ADDENDUM NO. 1
TO
SPECIFICATIONS
FOR THE
GLOUCESTER CITY BOARD OF EDUCATION
CONTRACT #06 – MEDIA CENTER AND MAIN OFFICE ALTERATIONS
AT
GLOUCESTER CITY MIDDLE SCHOOL

Gloucester City Board of Education
1300 Market Street
Gloucester City, NJ 08030

LAN Job #2.20457.06
January 10, 2024

1 1ST FLOOR PROPOSED MAIN OFFICE PLAN
A2.01 1/8" = 1'-0"

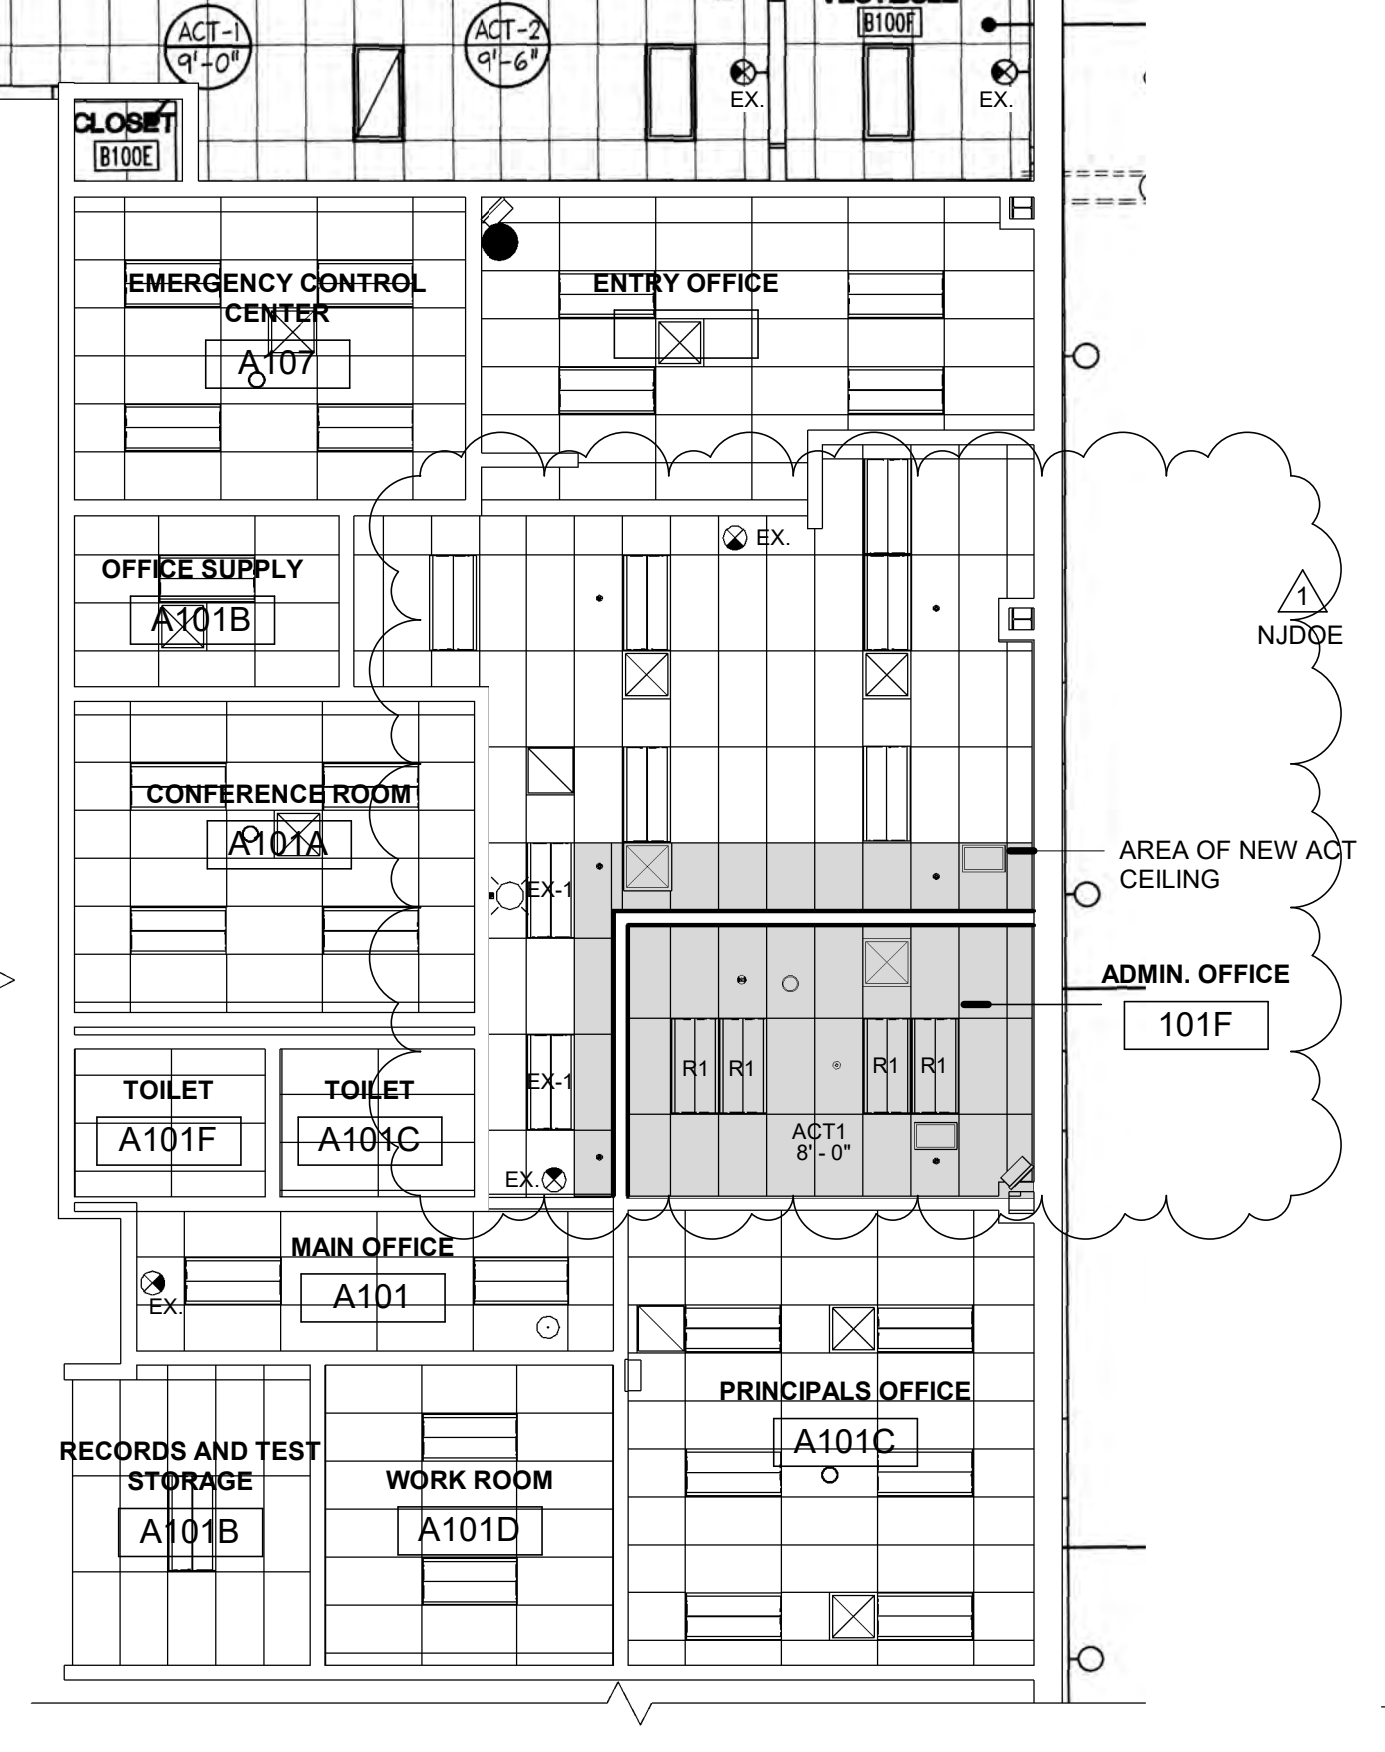
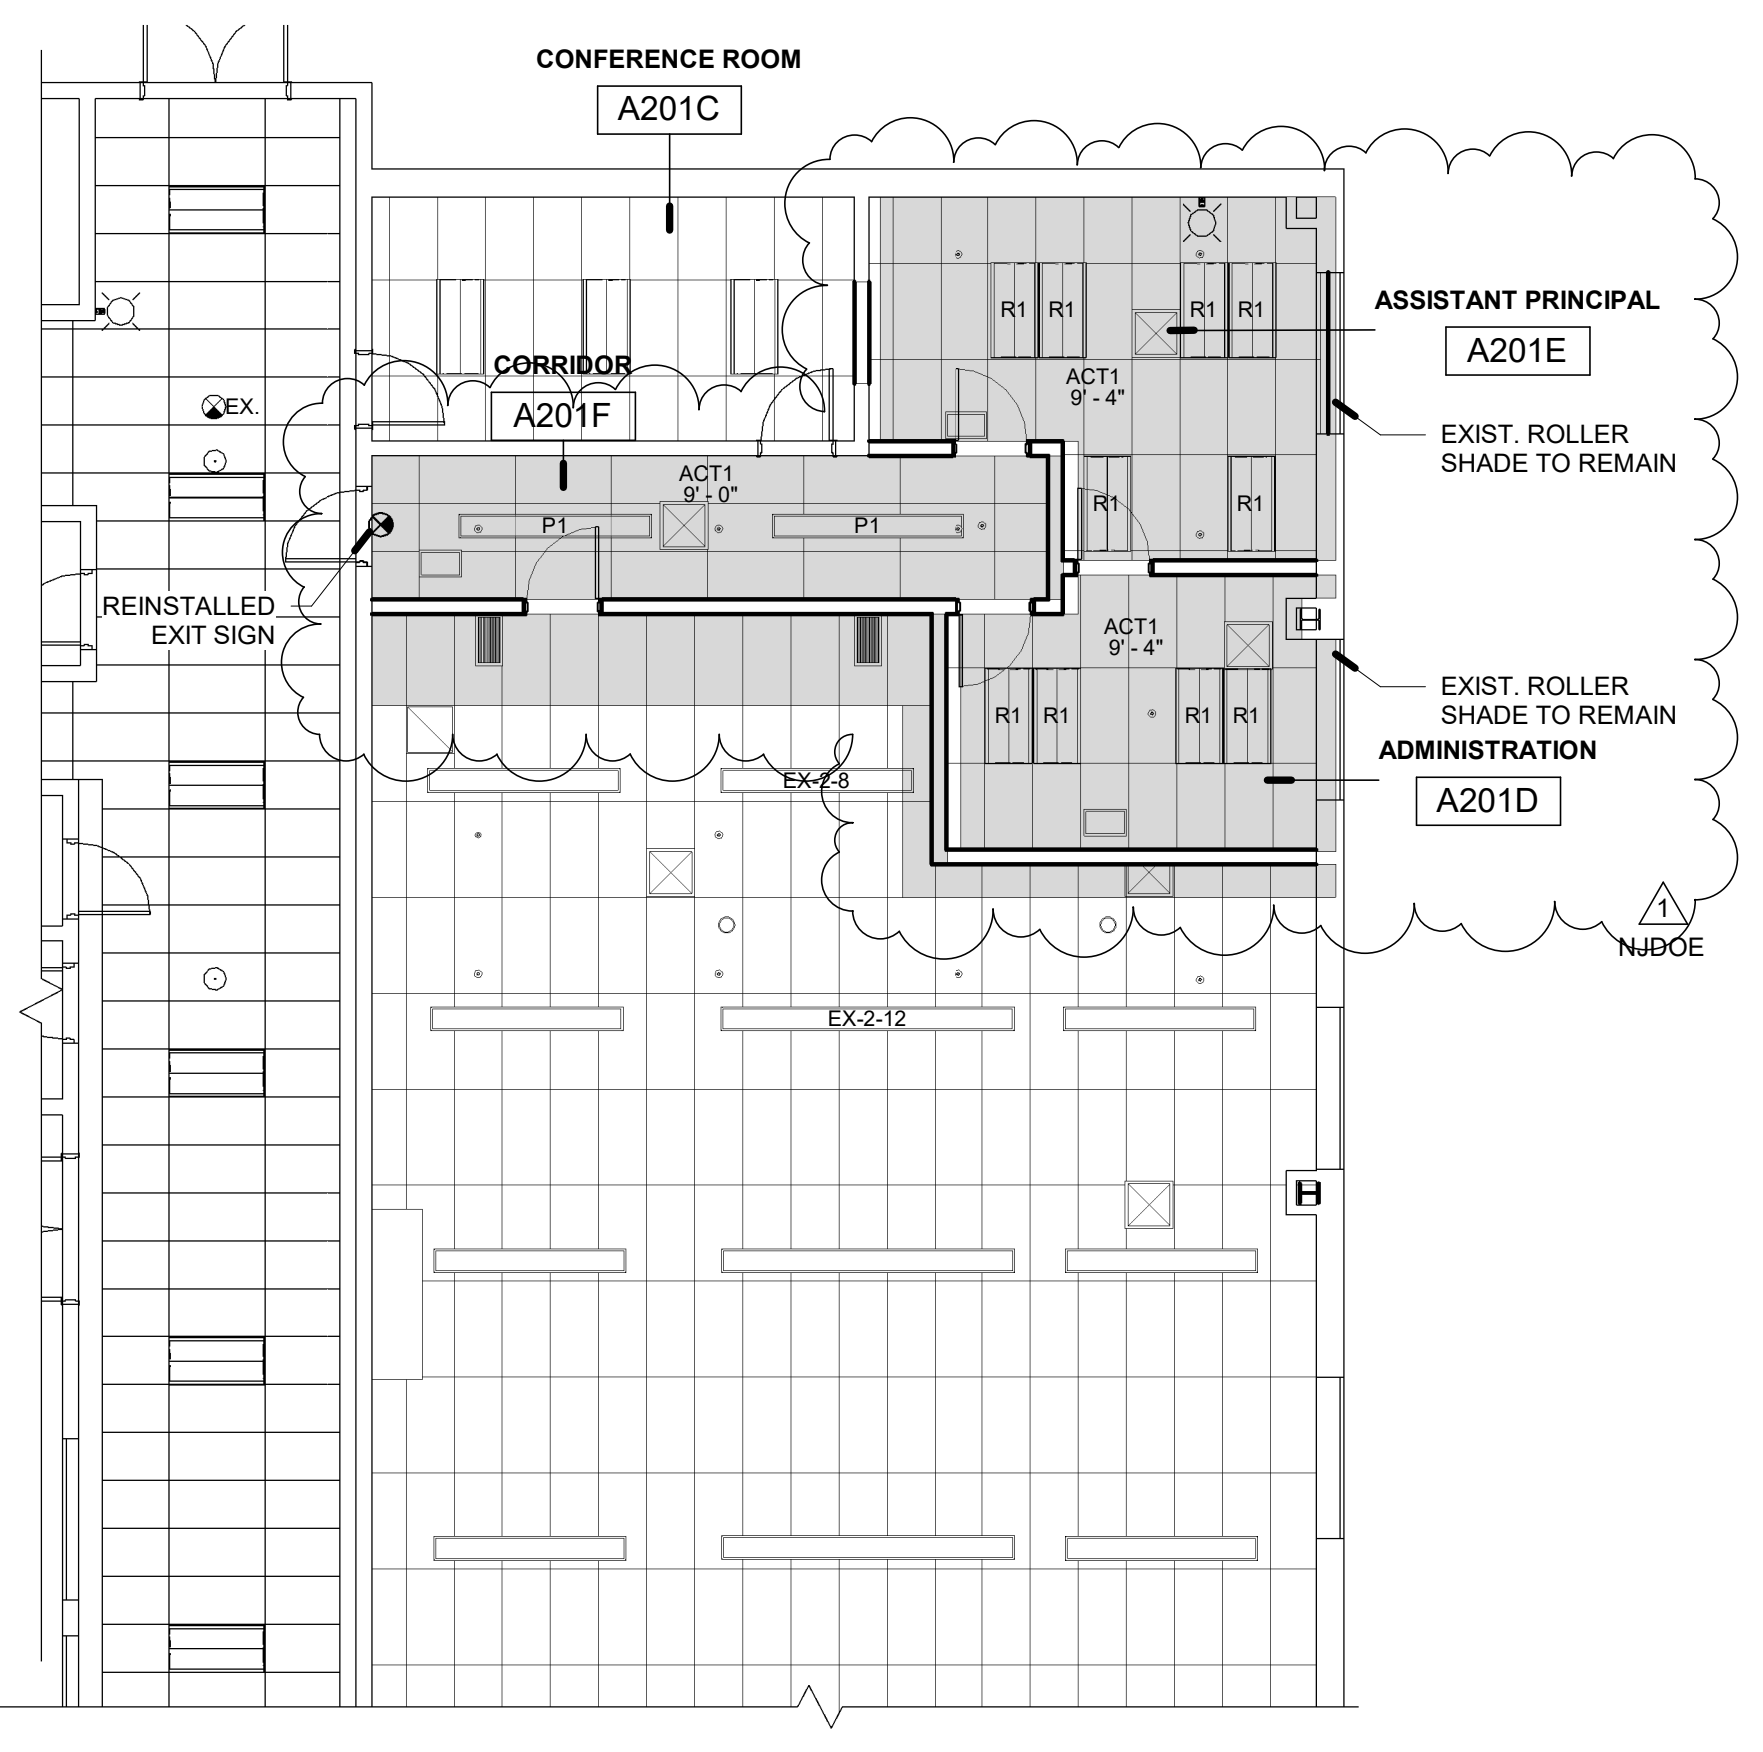
8. Q: Can the architect confirm rooms on the finish schedule? There are rooms on the drawing sheet that are marked as CPT 1 and not on the finish schedule.

A: Refer to revised finish schedule on Drawing Sheet A2.01, Enclosure #3 attached.

1 DOOR TYPES
A6.01 1/4" = 1'-0"

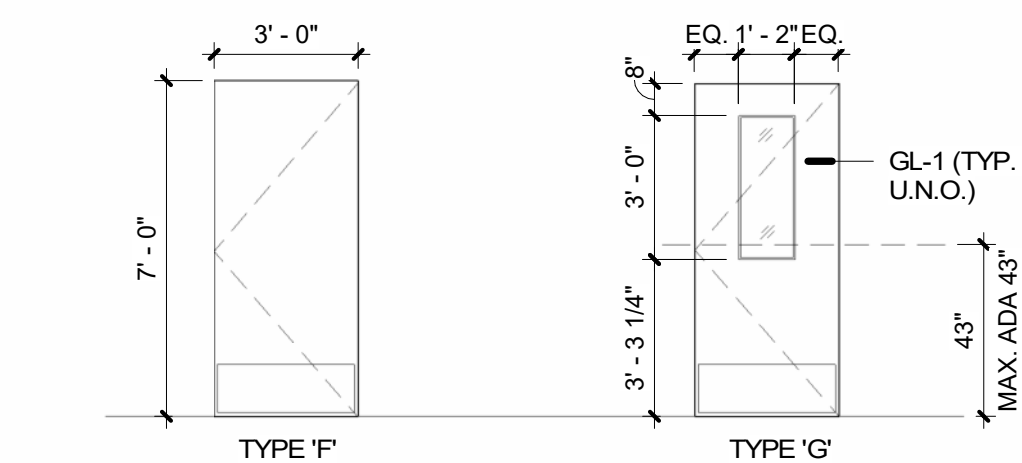
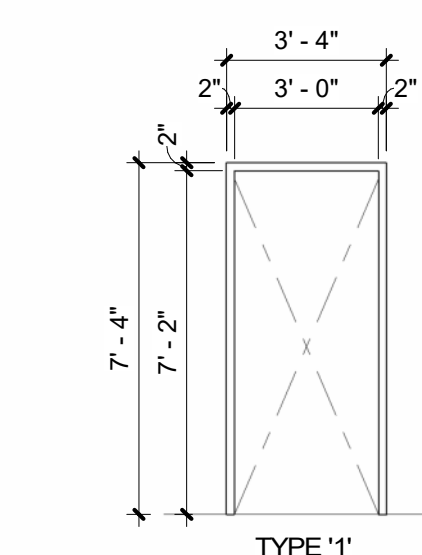
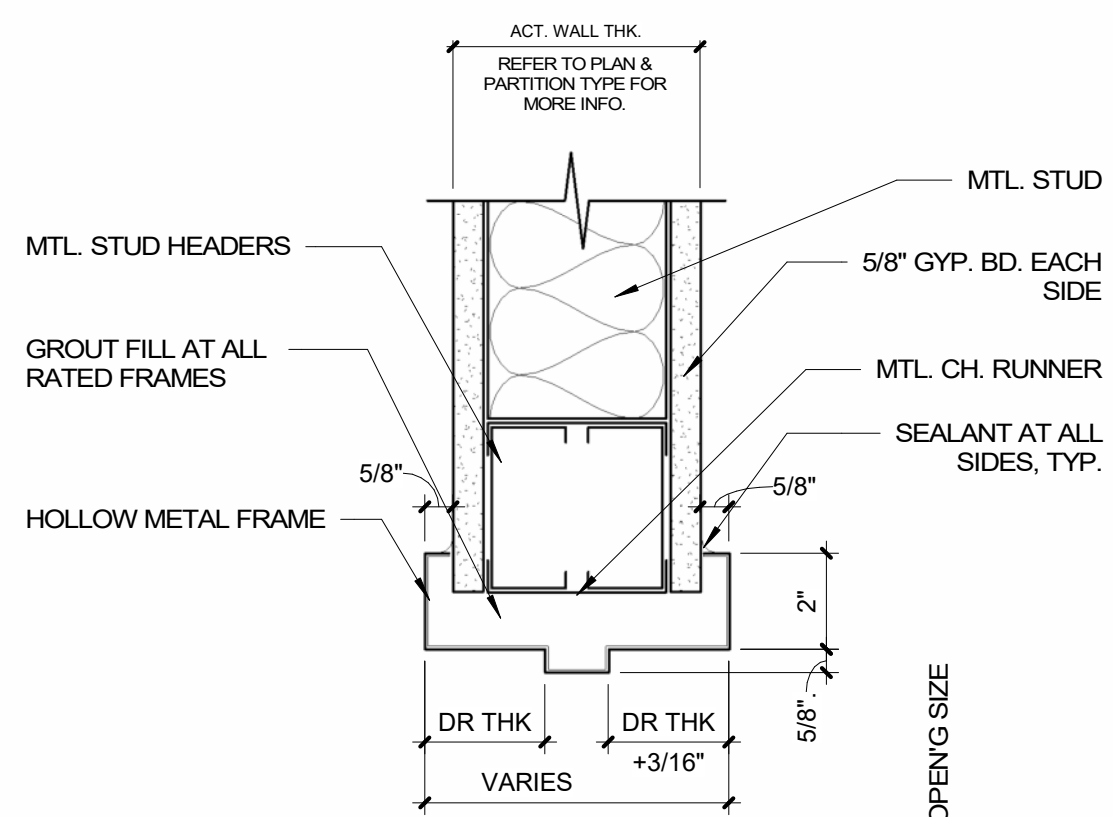
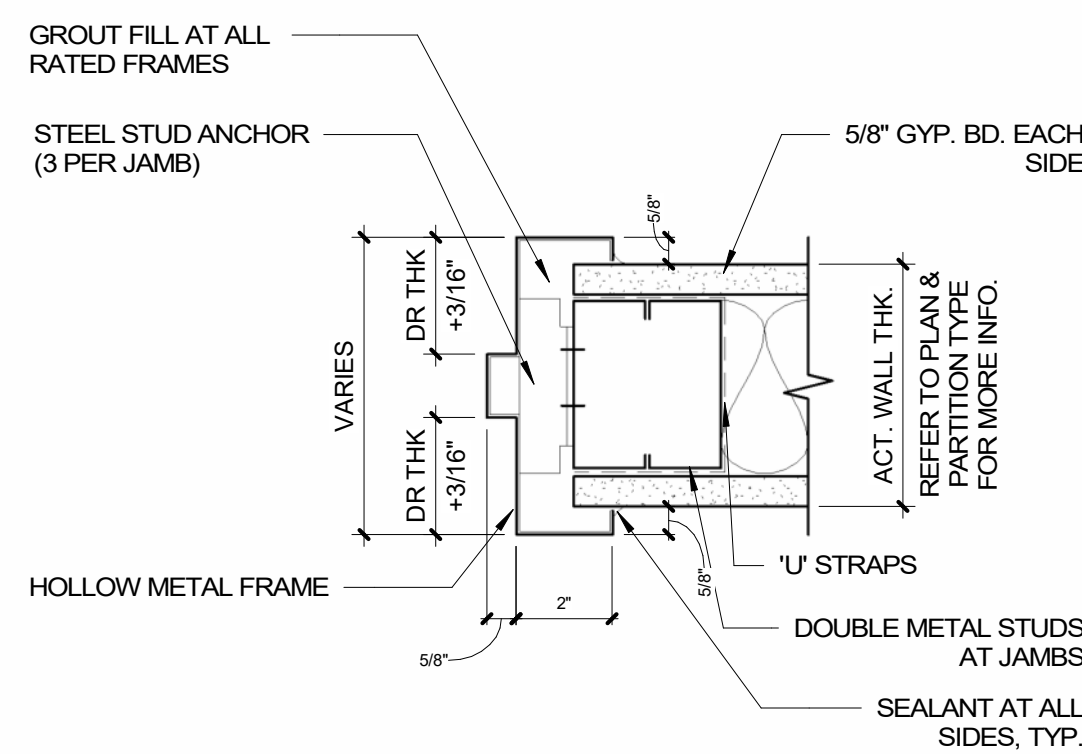
Dwg. No.	Addendum Requirements
T.01	ADD Sheet FP.01 'FIRE PROTECTION PLAN' to Drawing Index.
T.03	Detail 1: Refer to attached ENCLOSURE #1, Drawing Sheet T.03 'WALL TYPES' for revised partition type detail.
A1.01	Detail 5 ADDED to ENCLOSURE #2, Drawing Sheet A1.01 'DEMOLITION PLAN'
A1.01	Detail 2: REVISED to show locations of existing sprinkler head and the locations of heads to be removed and relocated.
A1.01	Detail 4: REVISED to show the locations of the existing sprinkler head and the locations of heads to be removed and relocated.
A2.01	Finish schedule has been REVISED. Refer to Question #08 of Addendum.
A2.01	Detail 2: 1 st Floor Proposed RCP REVISED to show the locations of the existing sprinkler and new pendent locations.
A2.01	Detail 4: 2 nd Floor Proposed RCP REVISED to show the locations of the existing sprinkler and new pendent locations.
A6.01	Refer to ENCLOSURE #4, Drawing Sheet A6.01 'DOOR SCHEDULE, DOOR TYPES & DETAILS' for REVISED door schedule.
